Response to Highways England Deadline 7 Documents 8.80, 8.83, 8.84, 8.86 & 8.89:

8.80 Applicant's Comments on any Additional Information or Submissions Received by Deadline 6

Last saved by: MOHAMMAD JAWOUD (2018-07-26) Last Printed: 2018-11-01
Filename: \\PROJECTS\60543032 - M42 JUNCTION 6\07 DELIVERABLES\07.2 CALCULATIONS\TRAFFIC FIGURES\2021-DOSSOMETHING - PEAK FLOWS.DWG

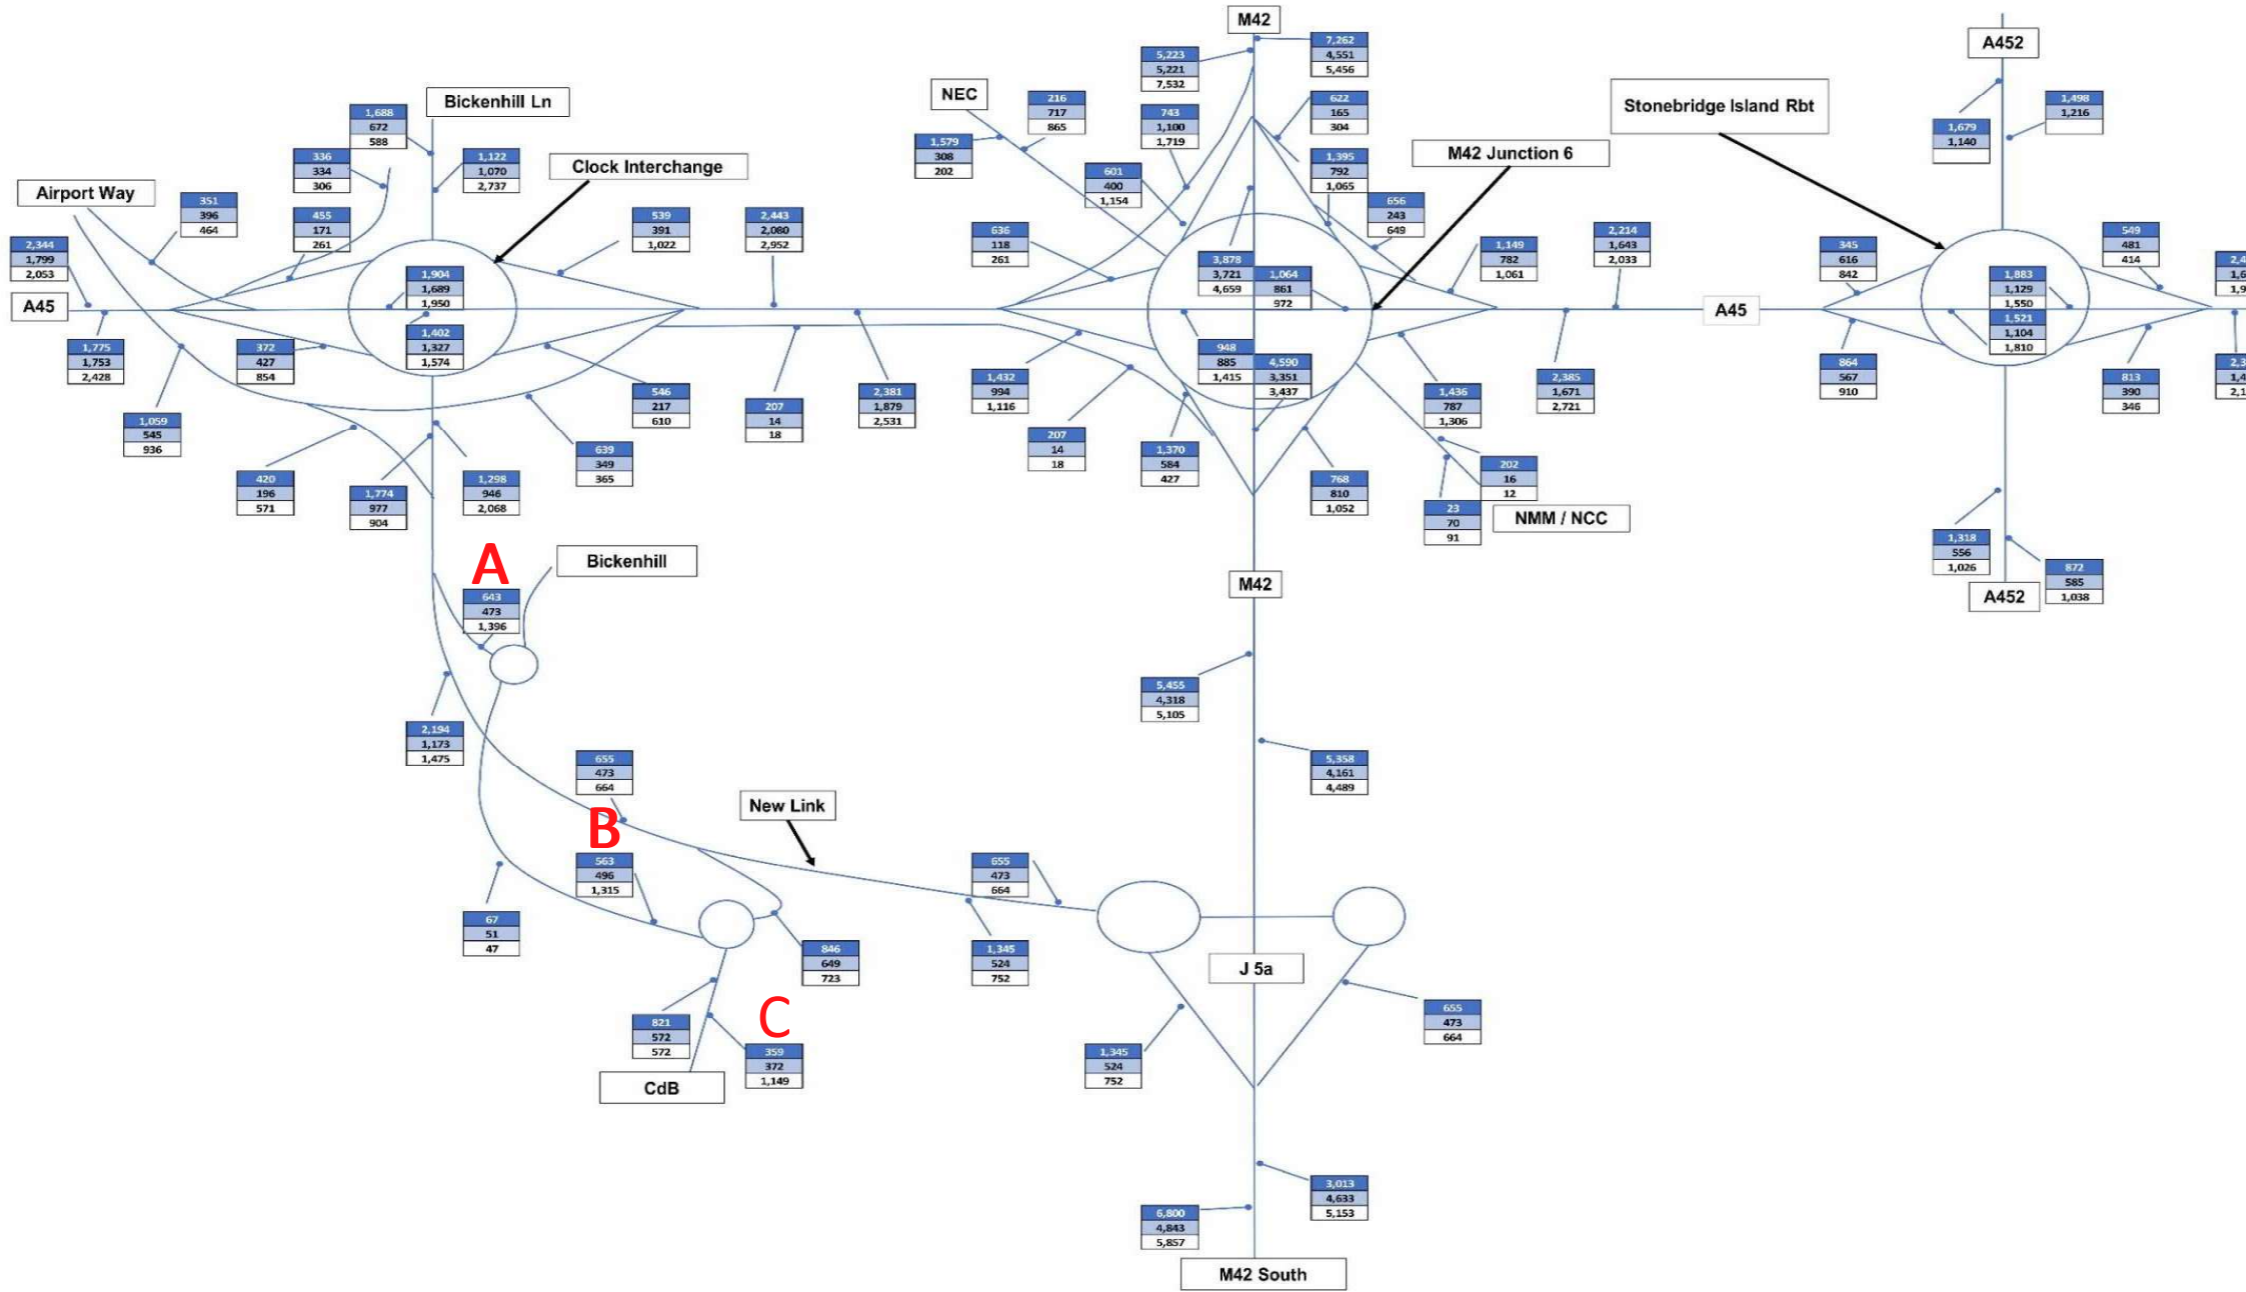
Figure 7.1 - Do-Minimum Peak Hour Flows (2016 Base – 2021 – 2041)

- All other roads on the diagram show an increase in Traffic Flow in year 2041 but Highways England are stating that Southbound Traffic Flow on Catherine de Barnes Lane will be lower during AM and PM hours, and higher during IP hours, in 2041 when compared to 2021
- Almost half the Traffic Flow in AM hours is going missing on the journey from the north end of Catherine de Barnes Lane to the south end
- There appears to be a false assumption that a lot of traffic is / will be using Shadowbrook Lane

Figure 7.2: DS 2021 and 2041 peak hour flows

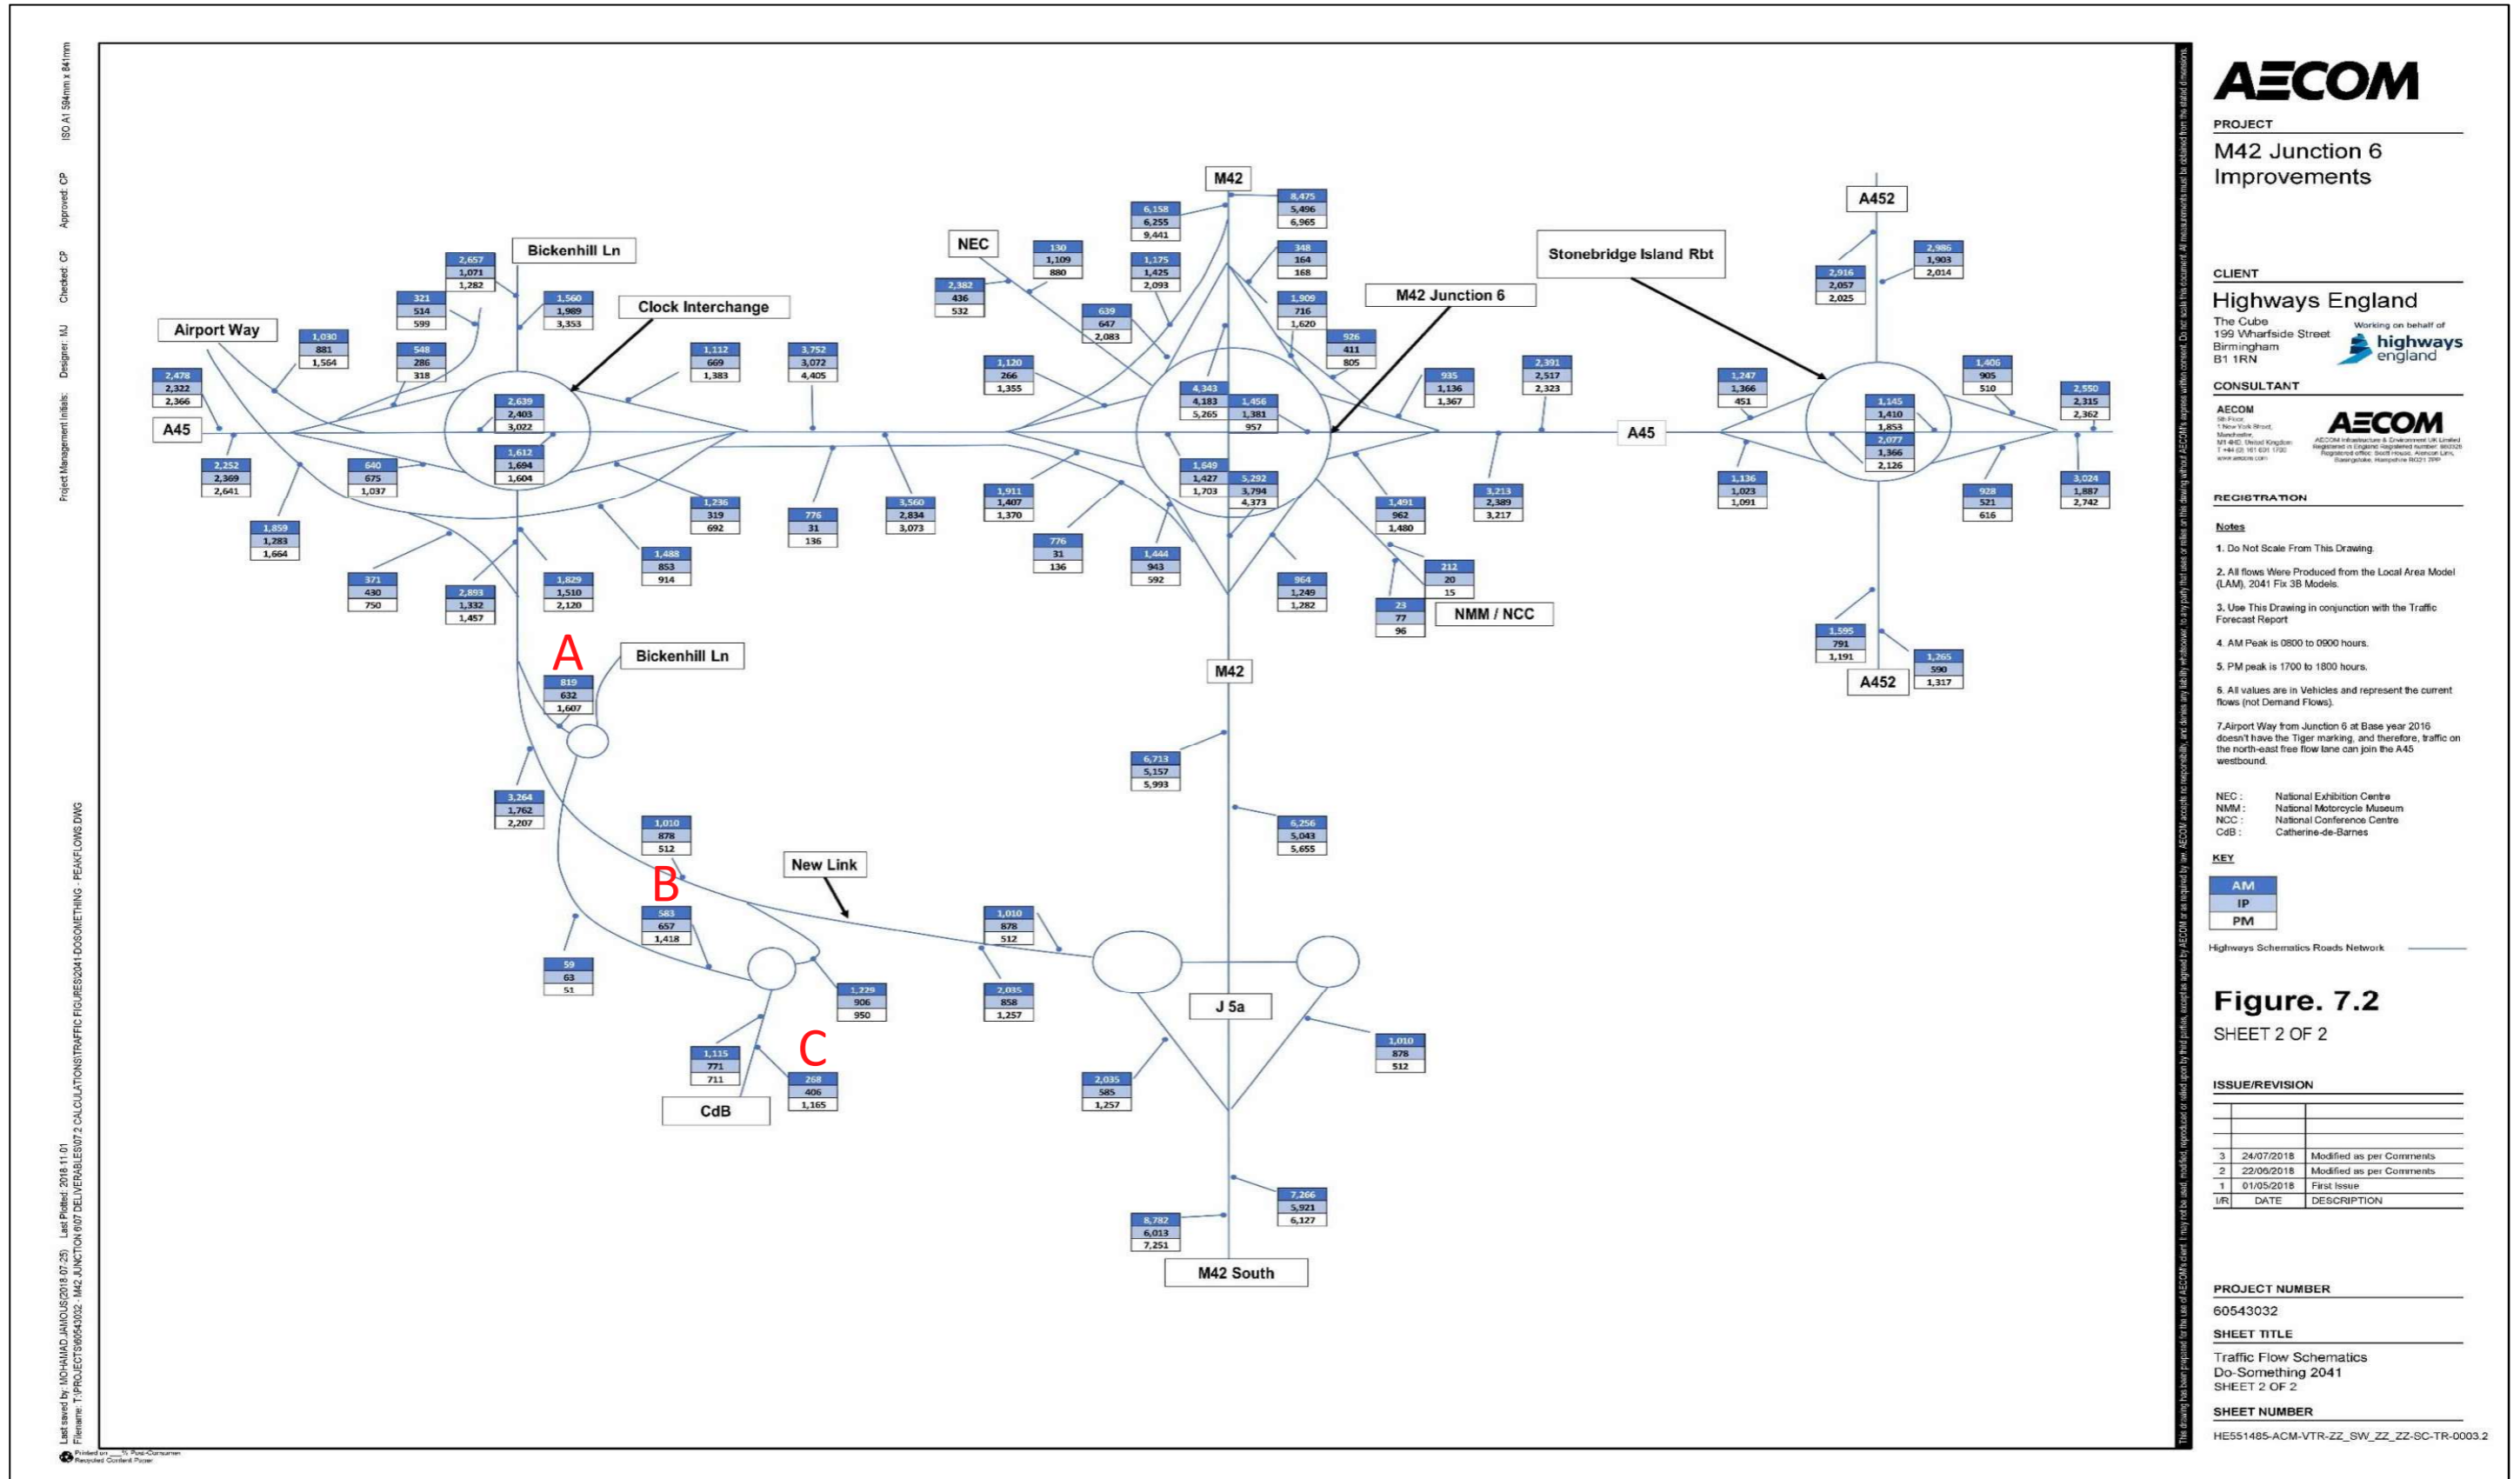
Figure 7.2 - Do-Something 2021 – 2041

- Do-Something will result in a higher southbound Traffic Flow of 1607 during PM hours in 2041 compared to the Do-Minimum Traffic Flow of 1390
- There is an increase in southbound Traffic Flow in 2041 at the north end of Catherine de Barnes Lane but there is a reduction in Traffic Flow at the south end

- There appears to be a false assumption that a lot of traffic is / will be using Shadowbrook Lane
- Most of the vehicles that arrive at Bickenhill Roundabout from the Mainline Link road in AM hours in 2041 will apparently not reach Hampton Lane Roundabout - 819 vehicles arrive at Bickenhill Roundabout but only 268 vehicles will get to Hampton Lane Roundabout

- More than a third of the vehicles that arrive at Bickenhill Roundabout from the Mainline Link road in IP hours in 2041 will apparently not reach Hampton Lane Roundabout - 632 vehicles arrive at Bickenhill Roundabout but only 406 vehicles will get to Hampton Lane Roundabout

- More than a quarter of the vehicles that arrive at Bickenhill Roundabout from the Mainline Link road in PM hours in 2041 will apparently not reach Hampton Lane Roundabout - 1607 vehicles arrive at Bickenhill Roundabout but only 1165 vehicles will get to Hampton Lane Roundabout

- Southbound Traffic Flow during inter-peak hours from Bickenhill Roundabout to Barber's Coppice Roundabout to Hampton Lane Roundabout is shown higher than during AM hours by 2041

Figure 7.3: DM AADT 24hr flows

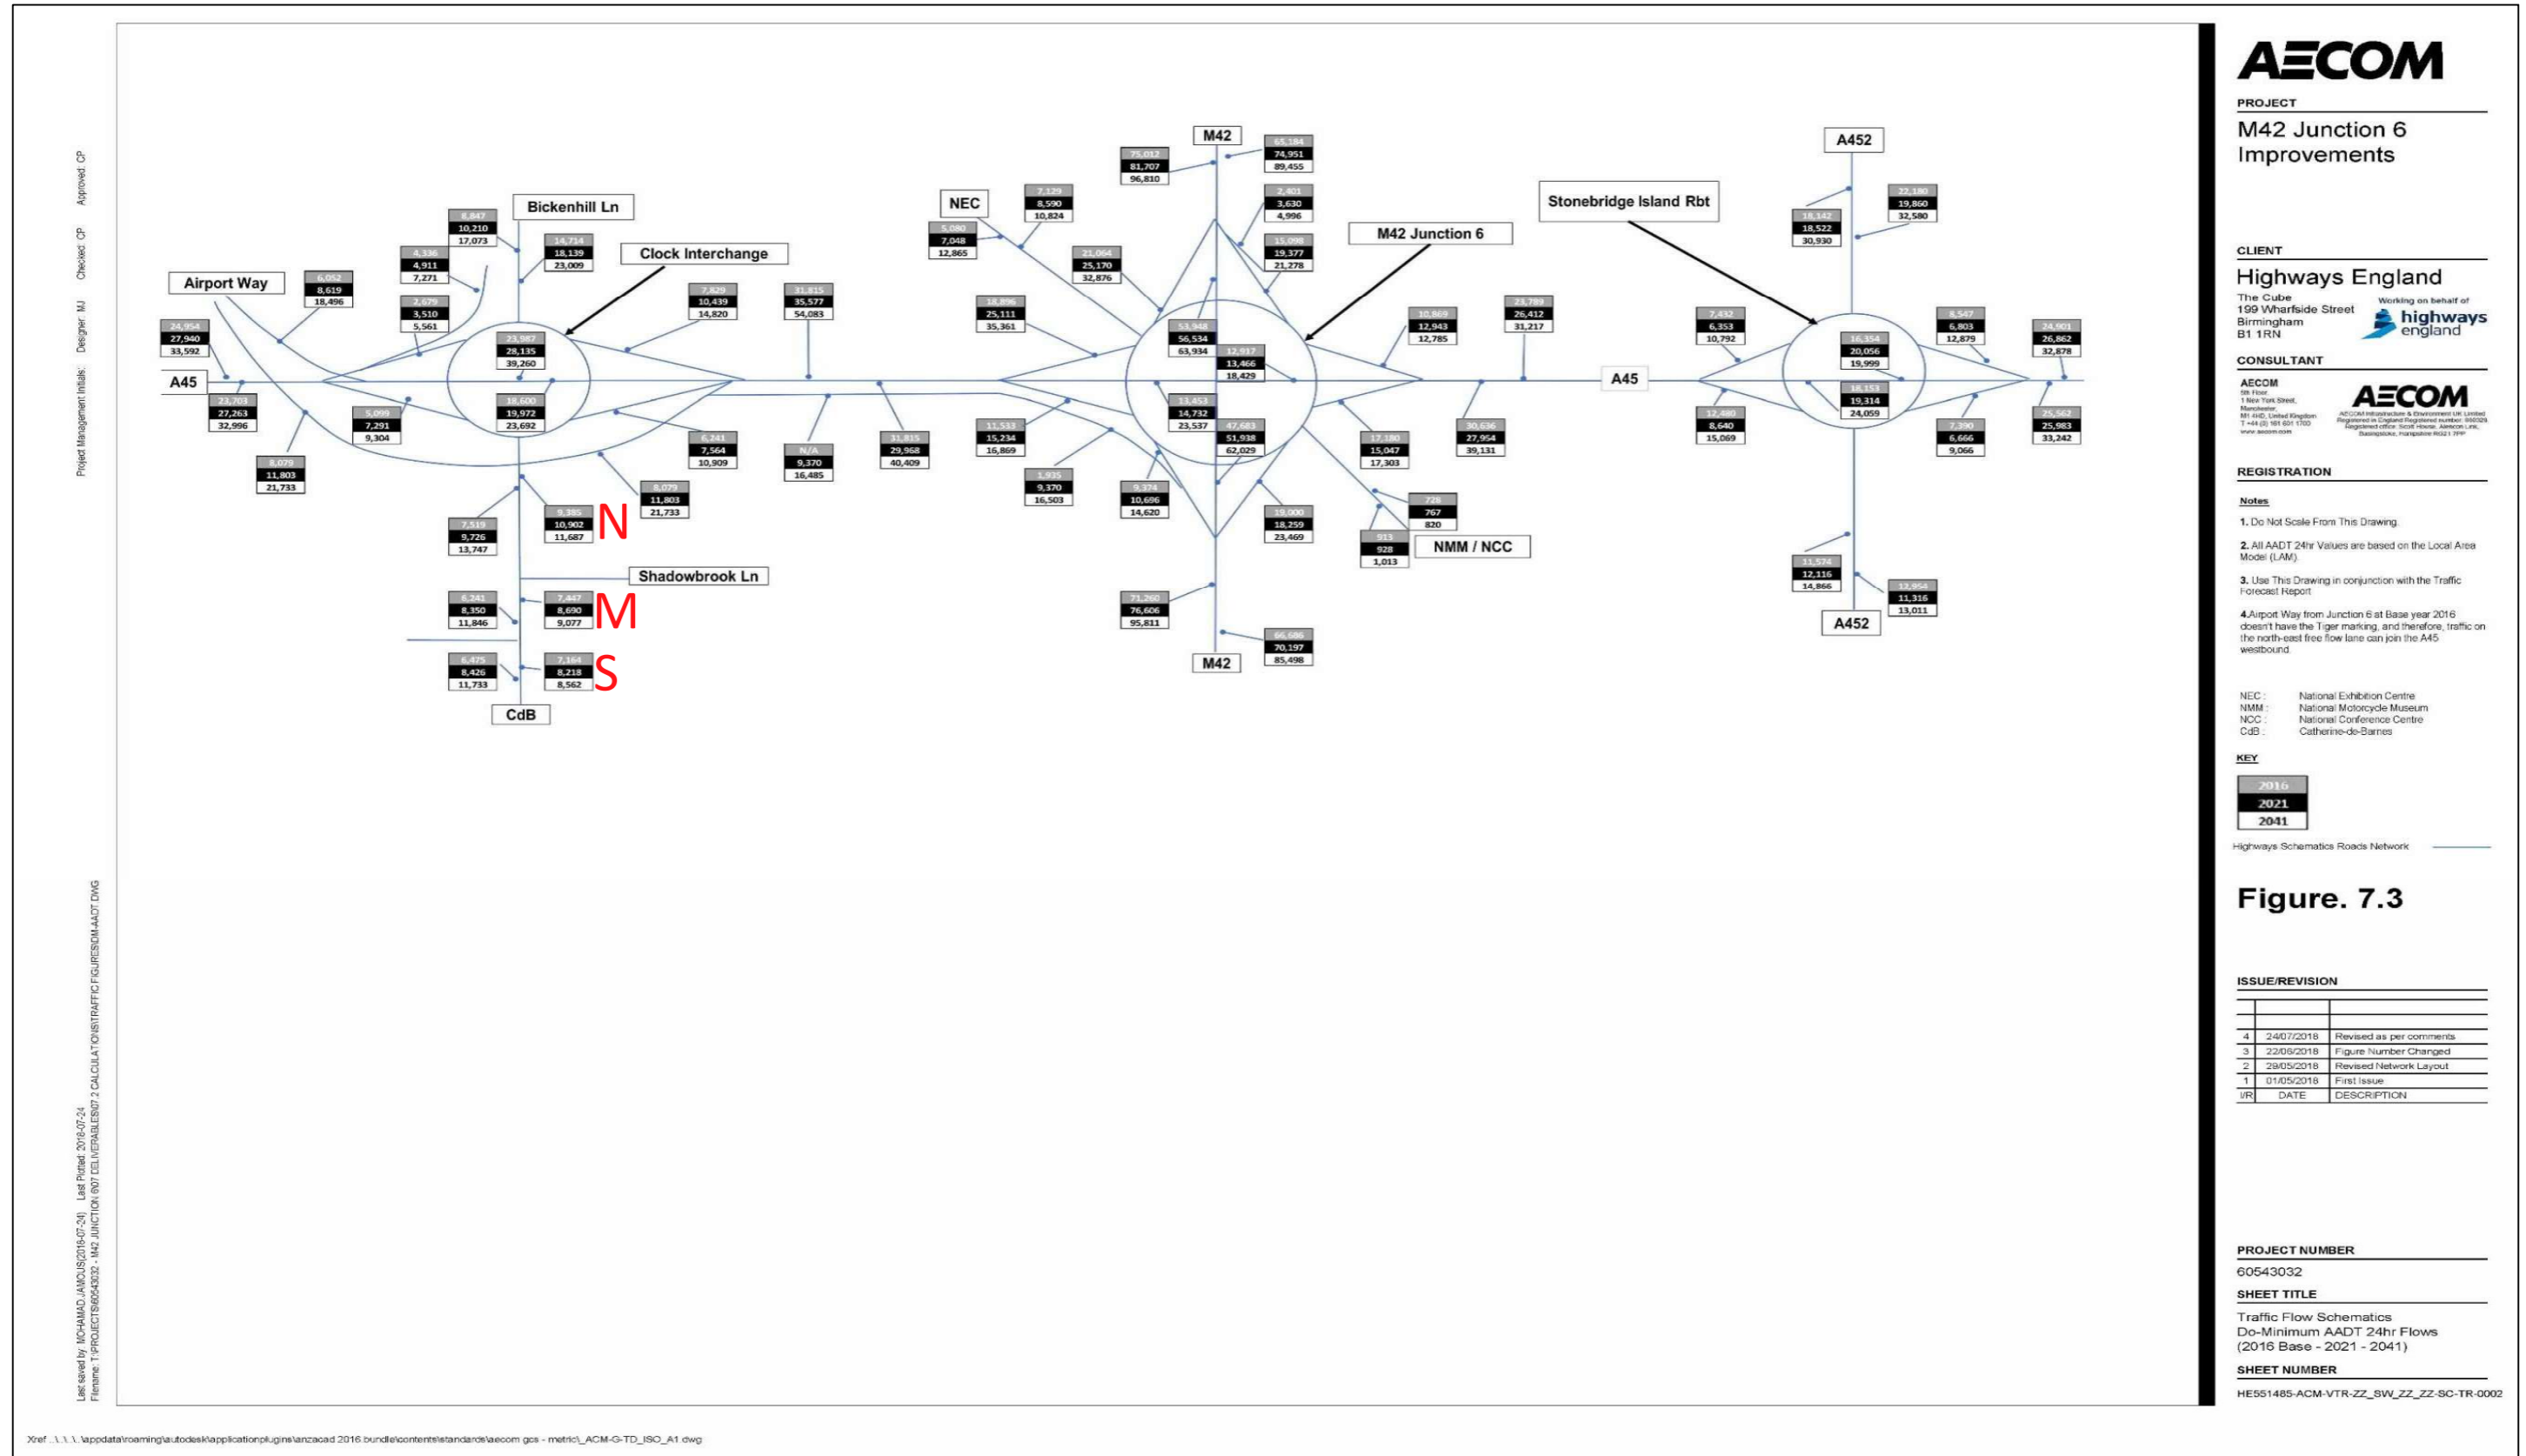
Figure 7.3 - Do-Minimum AADT 24hr Flows (2016 Base – 2021 – 2041)

- It appears that a lot of vehicles are going missing on the journey from the north end of Catherine de Barnes Lane to the south end
- More than a quarter of the vehicles that start their journey at the north end of Catherine de Barnes Lane will apparently not reach the south end - 11687 vehicles start their journey at the north end but only 8562 vehicles get to the south end.
- There appears to be a false assumption that a lot of traffic is / will be using Shadowbrook Lane
